Project	<b>IEEE 802.16 Broadband Wireless Access Working Group</b> < <a href="http://ieee802.org/16">http://ieee802.org/16</a> >
Title	<b>Fixing mappings between primitive functions and NCMS services</b>
Date Submitted	<b>2007-03-14</b>
Source(s)	Ronald Mao, Achim Brandt, Erik Colban <a href="mailto:rmao@huawei.com">rmao@huawei.com</a> Huawei, Siemens, NextWave
Re:	Contribution on comments to IEEE 802.16g/D8
Abstract	The contribution proposes a resolution to the Sponsor Ballot comment 106.
Purpose	Adoption
Notice	This document has been prepared to assist IEEE 802.16. It is offered as a basis for discussion and is not binding on the contributing individual(s) or organization(s). The material in this document is subject to change in form and content after further study. The contributor(s) reserve(s) the right to add, amend or withdraw material contained herein.
Release	The contributor grants a free, irrevocable license to the IEEE to incorporate text contained in this contribution, and any modifications thereof, in the creation of an IEEE Standards publication; to copyright in the IEEE's name any IEEE Standards publication even though it may include portions of this contribution; and

Figure 1a: Illustration of the Network Control and Management System (Informational)

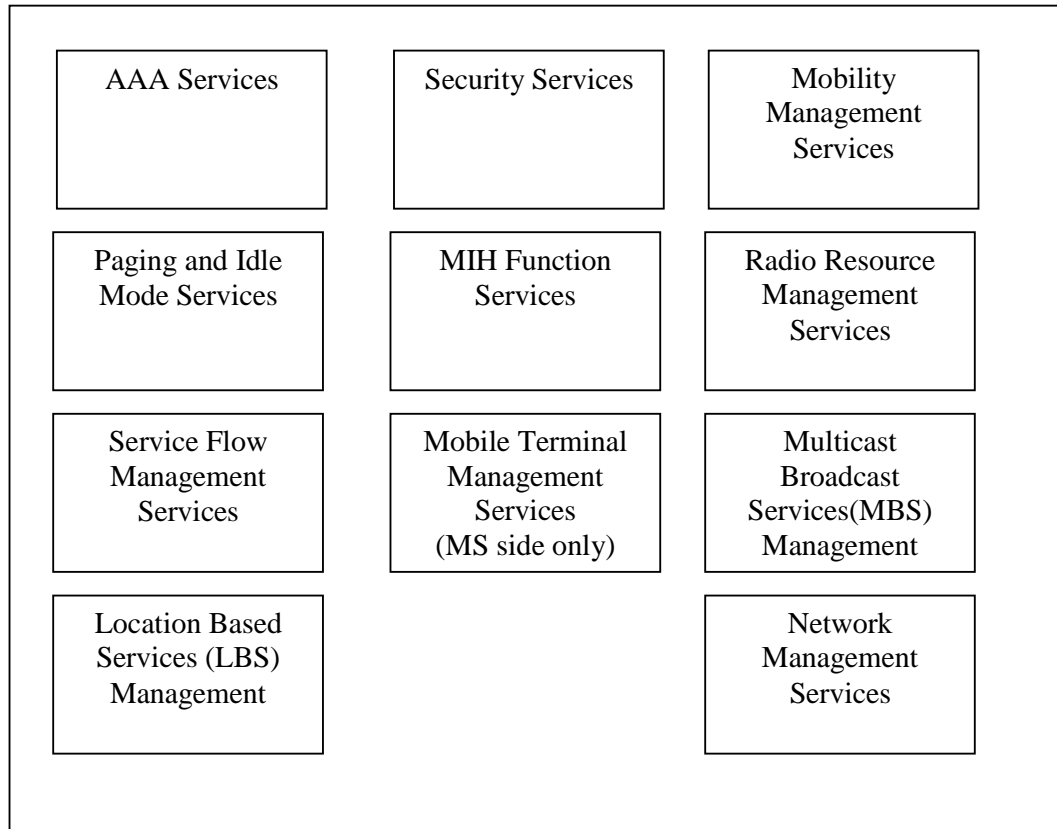
- 1) Add box “Mobile Terminal Management Services (MS side only)” in Figure 1a.
- 2) Specify the mapping of primitive functions in Section 14 to NCMS services as follows,
  - Accounting: AAA Services
  - Security: AAA and Security Services
  - IP Configuration: Mobility Management Services
  - Subscriber Mode: Paging and Idle Mode Services
  - Network Entry and Exit: Service Flow Management Services and Mobility Management Services
  - Quality of Service: Service Flow Management Services

[Modify Figure 1a as follows ]
